00S37

Recall - Park Brake Control Modification

RECALL - PARK BRAKE CONTROL MODIFICATION

Certain 1994 - 2001 Model Year Mustang Vehicles Equipped With Manual Transmission - Park Brake Control Assembly Modification

FIGURE 6

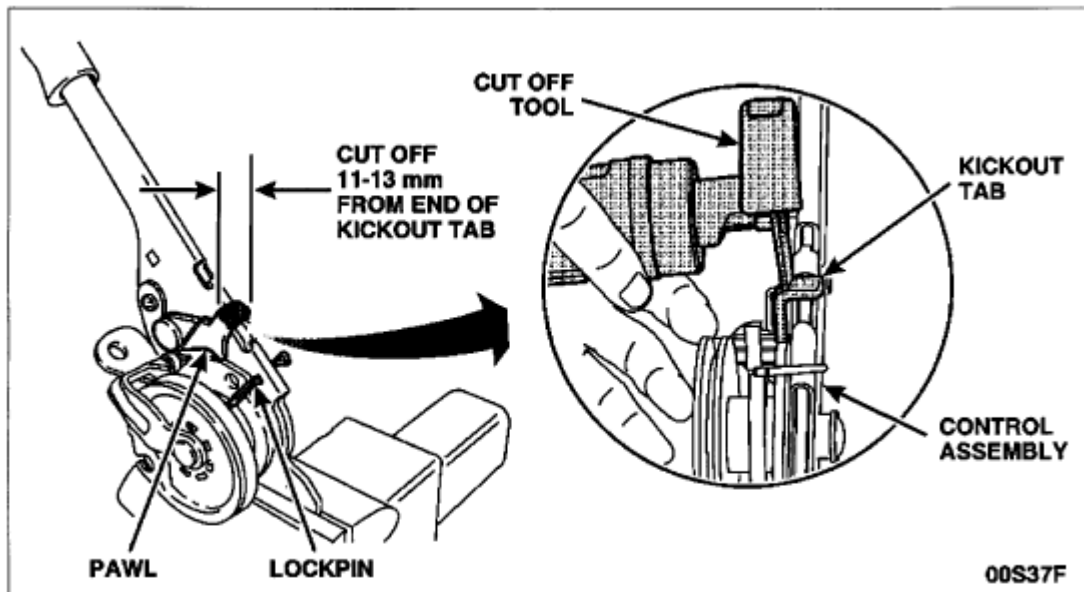
- CAUTION Be sure to cut only the kickout tab. Do not cut the handle or any other part of the control assembly.

3.-Using a suitable cutoff tool, remove 11-13 mm from the end of the kickout tab on the self-adjust pawl.

Remove any burrs. See Figure 6.

FIGURE 8

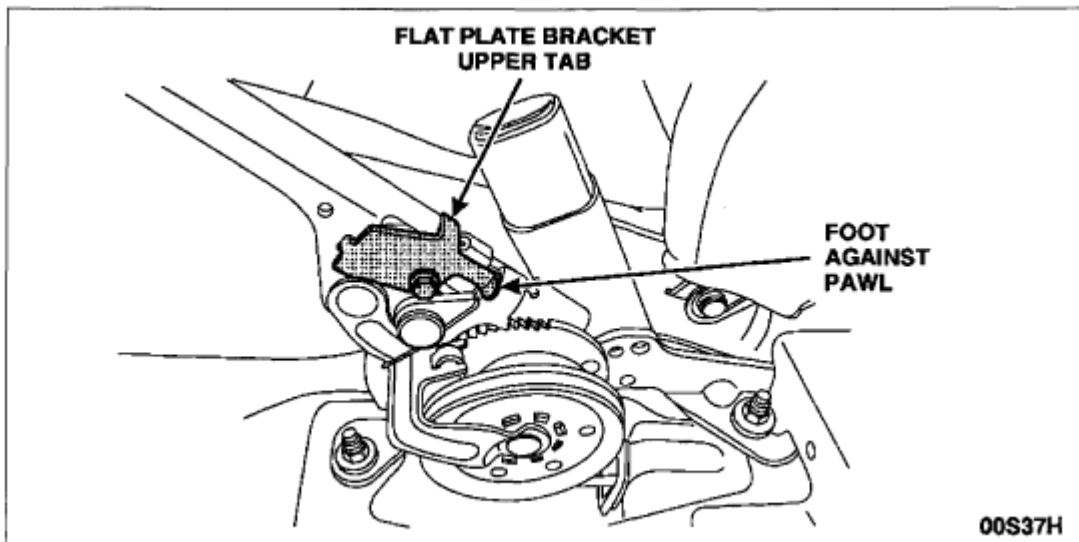
- On 2001 model year vehicles, position the flat plate bracket on the control assembly. Make sure the upper tab of the bracket is flush against the control assembly and the bracket is positioned as far rearward as possible so the foot of the bracket is against the pawl. Install the self-tapping screw and tighten to 3.2 Nm (29 lb-in). See Figure 8.

FIGURE 9

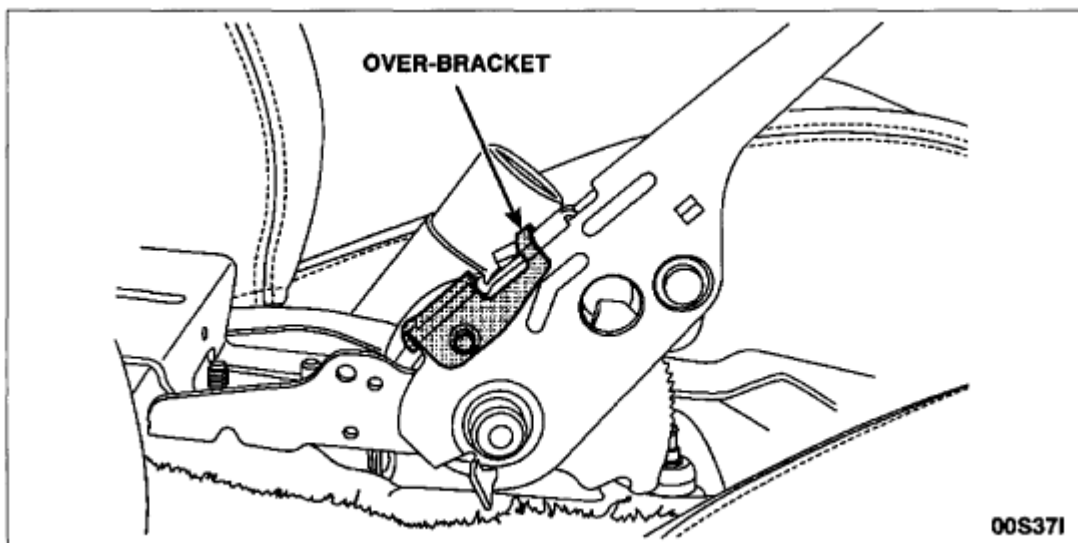
- On 1994-2000 model year vehicles, position the over-bracket on the control assembly as shown in the illustration. Make sure the over-bracket mounting hole is aligned with the lockpin hole on the control assembly. Install the self-tapping screw and tighten to 3.0 Nm (27 in-lb). See Figure 9.

FIGURE 6

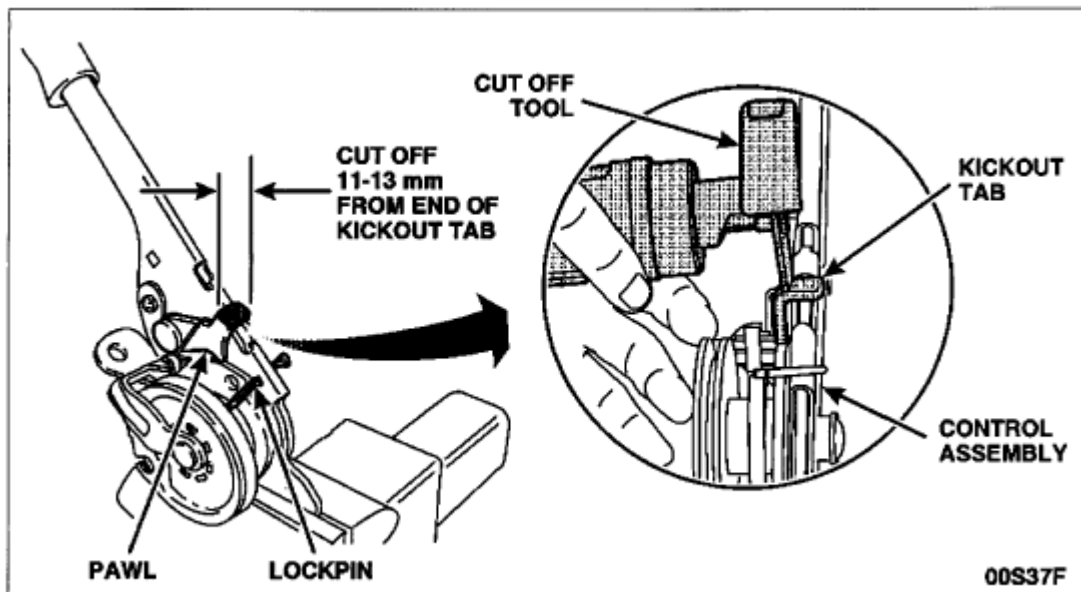
- CAUTION Be sure to cut only the kickout tab. Do not cut the handle or any other part of the control assembly.

3. Using a suitable cutoff tool, remove 11-13 mm from the end of the kickout tab on the self-adjust pawl. Remove any burrs. See Figure 6.

FIGURE 8

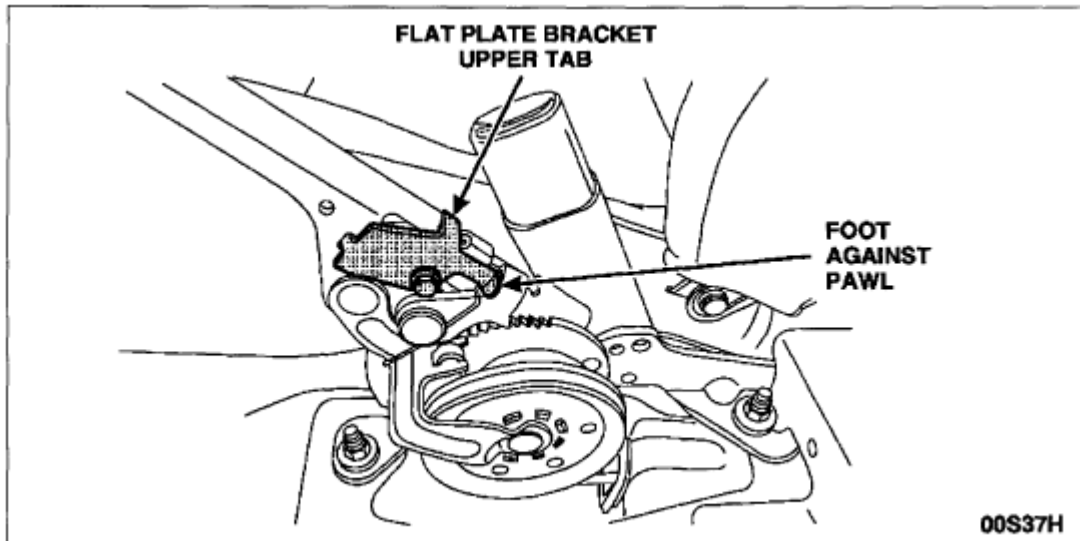
- On 2001 model year vehicles, position the flat plate bracket on the control assembly. Make sure the upper tab of the bracket is flush against the control assembly and the bracket is positioned as far rearward as possible so the foot of the bracket is against the pawl. Install the self-tapping screw and tighten to 3.2 Nm (29 lb-in). See Figure 8.

FIGURE 9

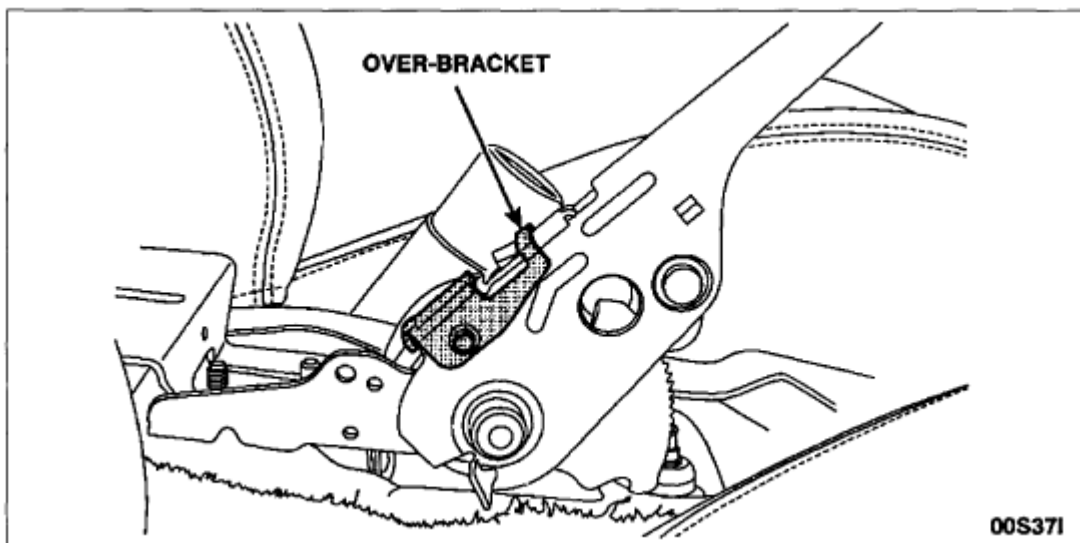
- On 1994-2000 model year vehicles position the over-bracket on the control assembly as shown in the illustration. Make sure the over-bracket mounting hole is aligned with the lockpin hole on the control assembly. Install the self-tapping screw and tighten to 3.0 Nm (27 in-lb). See Figure 9.
